# Keystone RV Company

6/12/25

## SAFETY ADVISORY # 25-468

### MORryde Clip-on Step Brackets

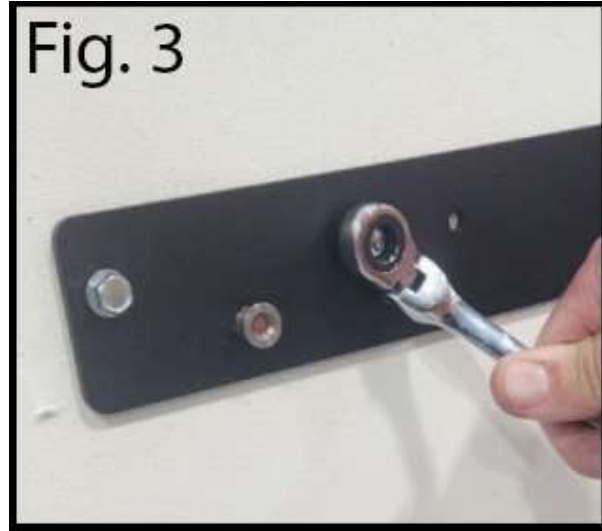
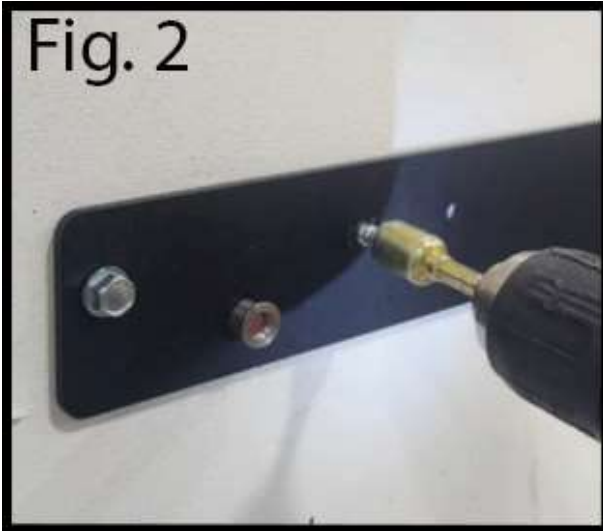
Remove the four mounting screws that secure the mounting bracket. Once removed, discard the original mounting bracket. See Figure 1.

Use the replacement kit KRV # 768047 to attach the new mounting bracket. To install the new bracket, start by installing four mounting screws into the four original holes. The above-mentioned holes will line up with the holes from the bracket that was removed. See Figures 2 & 3.

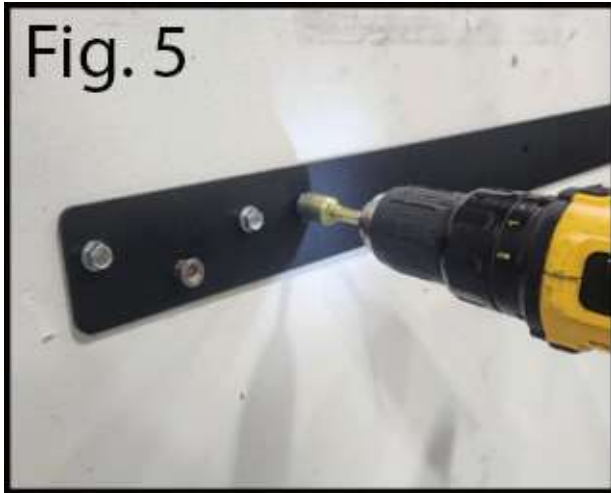
Use a drill and 3/16" drill bit to pre-drill pilot holes for the three new holes. See Figure 4.

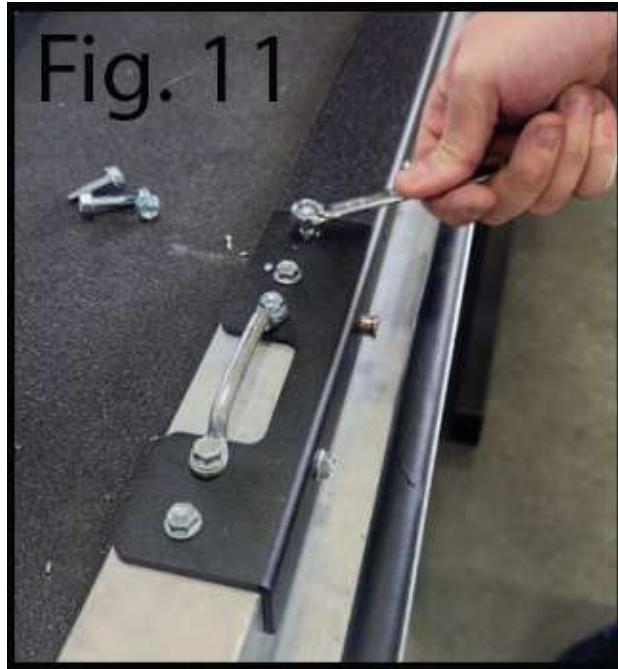
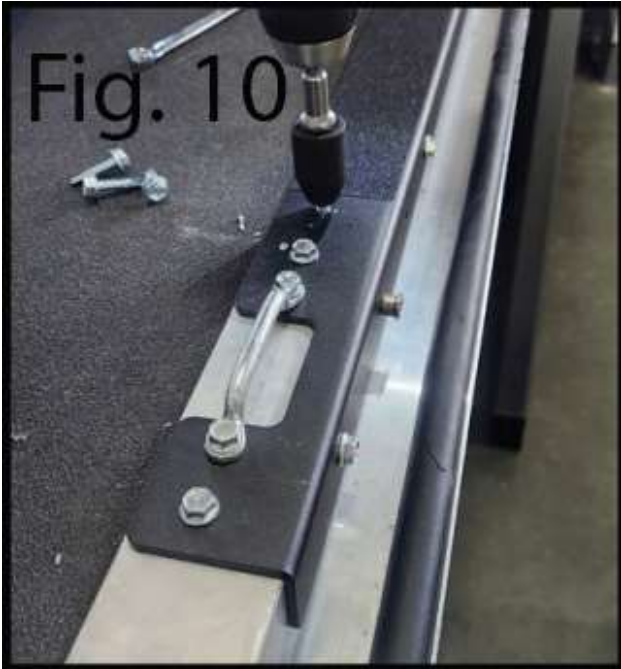
Use the replacement kit KRV # 768048 to attach the new mounting bracket. To install the new bracket, start by installing 12 mounting screws into the 12 original holes. The above-mentioned holes will line up with the holes from the bracket that was removed. See Figure 9.

Use a drill and 3/8" bit to install the four new screws in the mounting brackets. See Figure 10 – Figure 11. This completes the repair for KRV # 768048.
